Name of Proposed Subdivision ORLEANS ON THE LAKE

ORLEANS ON THE LAKE

Re: First Review
Orleans on the Lake
ROK 84841

Re: Second Review
Orleans on the Lake
ROK 84841

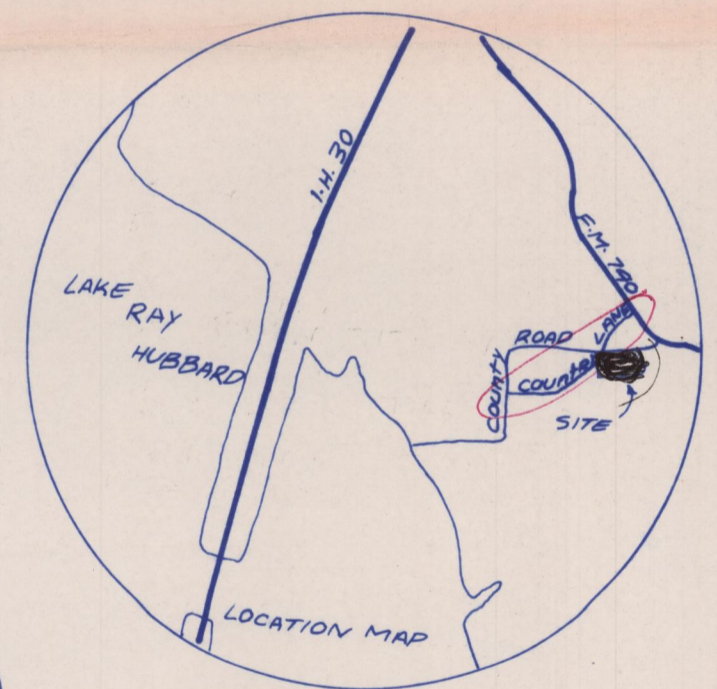
1. Summer Lee Drive in legal and on location map.
2. Need volume and page in legal description.
3. Public streets and dedication.
4. Summer Lee/Bourbon Street intersection design needs flare to south.
5. Bourbon Street Loop or Circle.
6. Tennis Court parking must be as on site plan, not head-in.

Please make sure you have addressed all Staff comments of 7/27/84 (label Summer Lee Drive, dedicate as public streets, fill in volume and page in legal description), then submit 2 mylars and 10 blue line copies for signatures and filing.
